## WEIGHTED LEVER BARS

### New Product for Trunnion Assemblies

This product notice is to inform you that we have added two new lever bars for our trunnion assemblies.

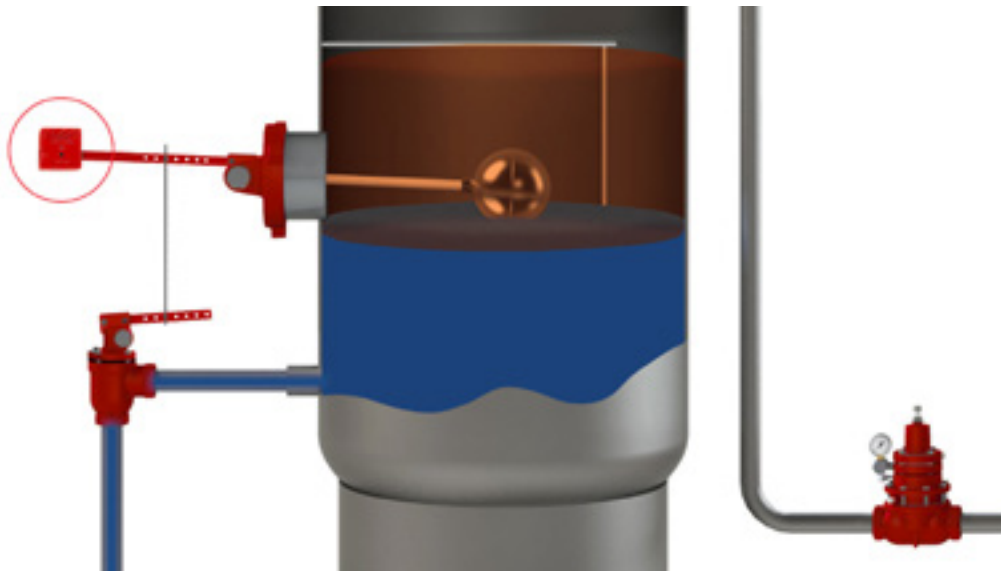
When the fluid density in a production vessel changes, it becomes difficult for the trunnion assembly float to maintain interface. Previously this required shutting in the vessel and re-weighting the float.

With the new lever bar, you can add or remove weights outside the vessel to counteract the fluid and help move the float up or down.

These lever bars and the weights must be ordered separately.
